October 18, 2016

04934 Version 1

Rubbing, Popping or Clicking From Front Door When Opening

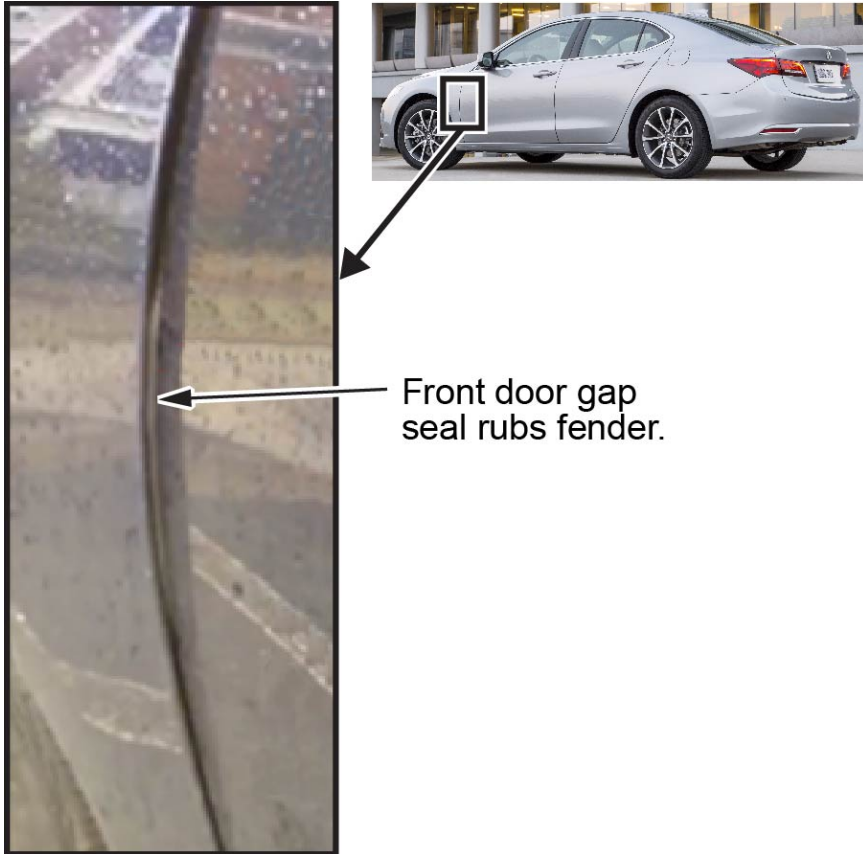
The door gap seal, on the leading edge of the front doors contacts and rubs against the front fender when opening the door.

Identify the side making the noise, and replace the front door gap seal on that affected side. **Do not** adjust the door or fender to resolve the noise because it may cause a road or wind leak noise inside the cabin.

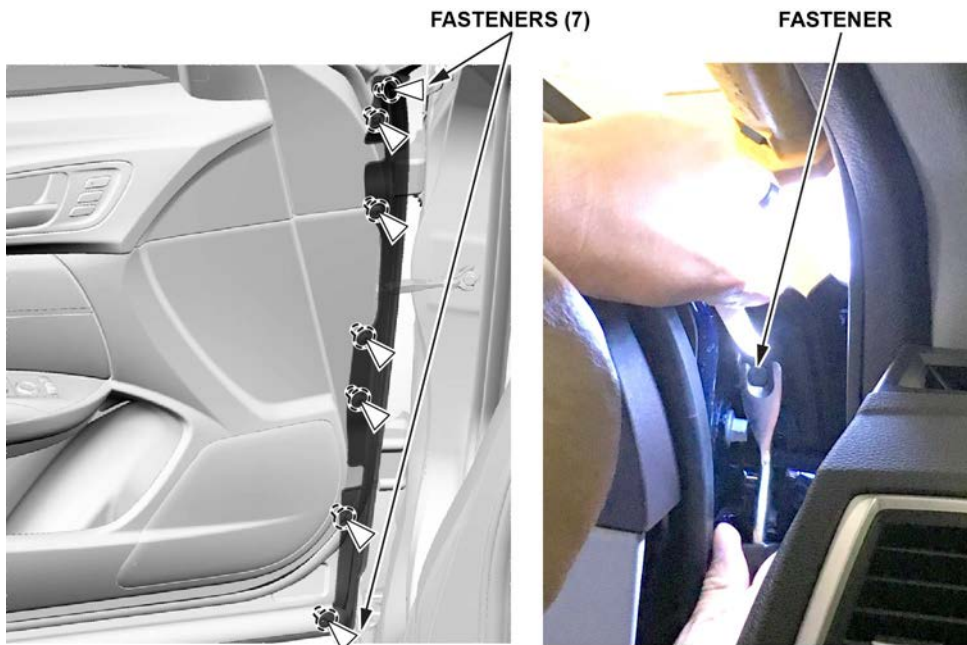
2. Open the front door on the side making the noise, and remove all of the fasteners on the front door gap seal.

3. Once all the fasteners are removed, pull the seal up and out to remove it from the doorjamb area.

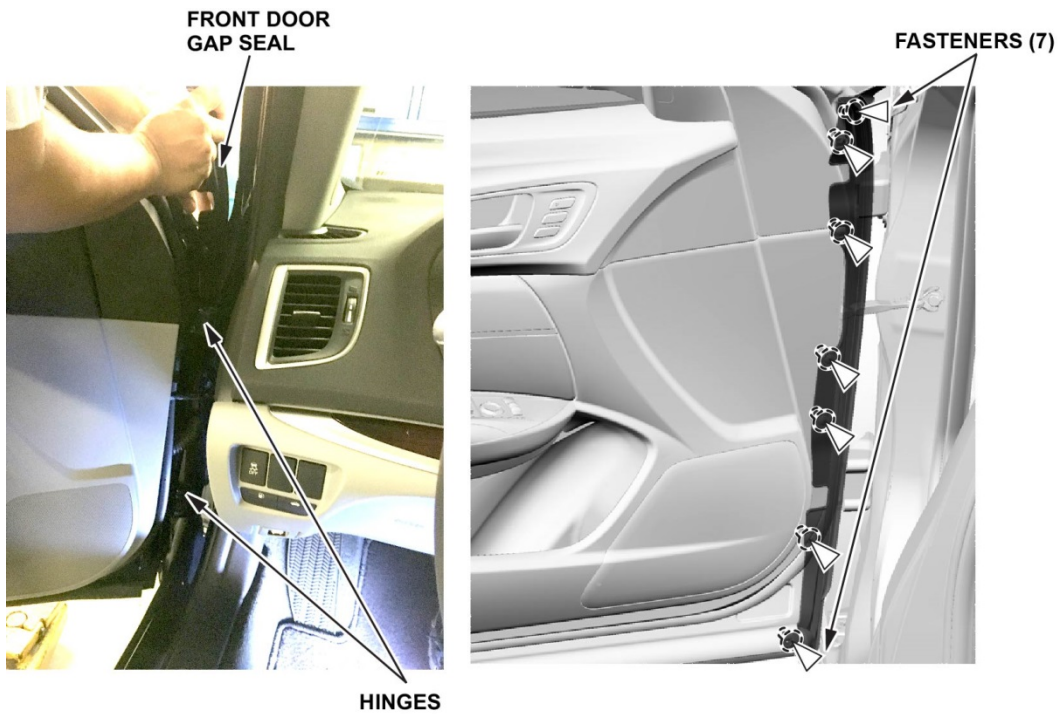
4. Install a new front door gap seal behind the door hinges, and install each fastener into its slotted hole.
